DEVIATION REVIEW AND DECISION FORM

Security Water District: Water System
Improvements - 2019

EXHIBIT A
TO DEVIATION REQUEST
FOR SECURITY WATER DISTRICT

WATER SYSTEM IMPROVEMENTS – 2019
SECURITY WATER DISTRICT

DEVIATION SKETCH

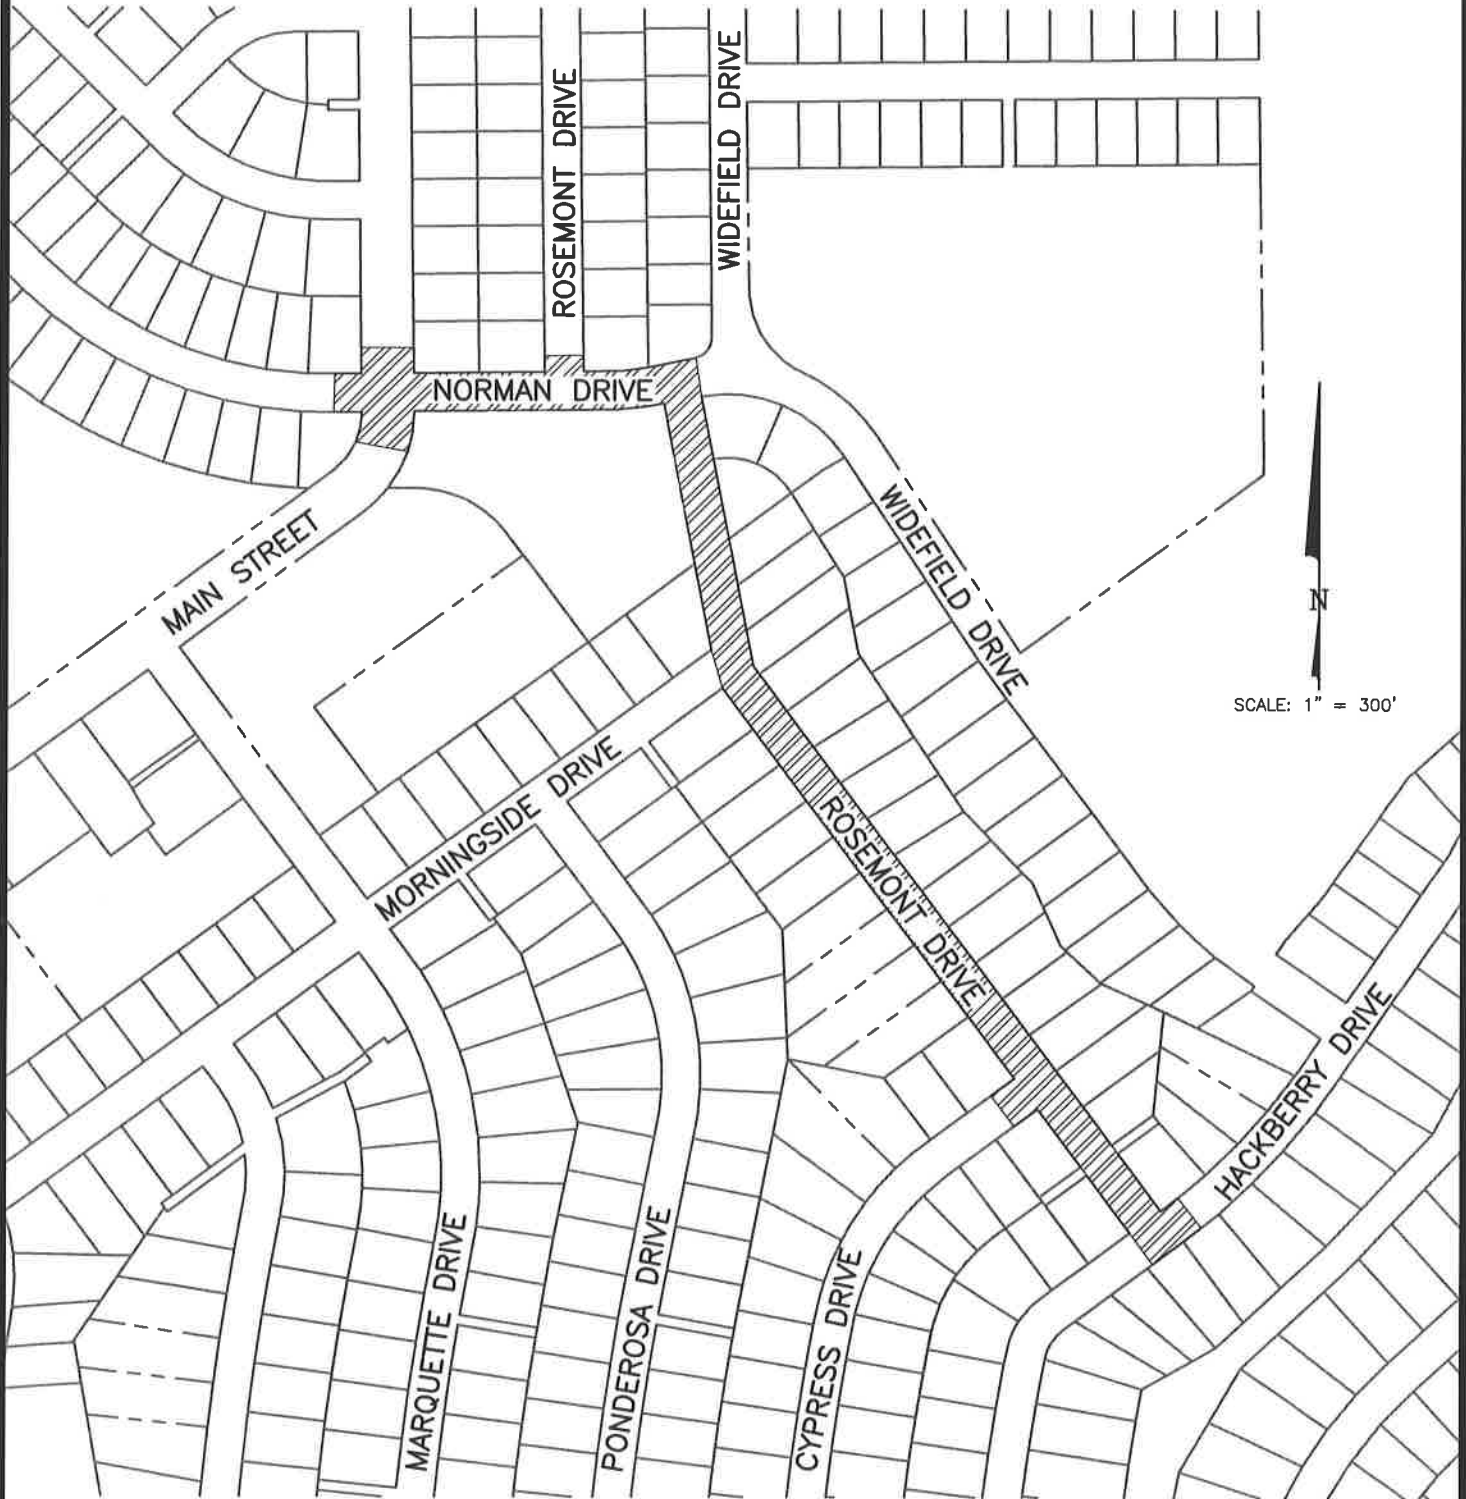
Proposed Nature and Extent of Deviation: The Security Water District requests a deviation to the requirement, allowing them to install water lines with the depth of cover as they historically have done, i.e. 6" lines: 4.5' cover; 8" lines: 4.3' cover; 10" lines: 4.2' cover; 12" lines and greater: 4' cover.

Reason for the Requested Deviation: See Attached Exhibit A

Summary: All new water lines installed by the Security Water District and all new water lines installed in new developments from this past year to over the past 40 years have been submitted and approved at the deviation depth of cover requested. See attached Deviation Sketch.

This request has been determined to have met the criteria for approval. A deviation from Section 4.3.6.A.1 of ECM is hereby granted based on the justification provided. Comments:
Vertical separation for all utilities must meet Federal & State Regulations
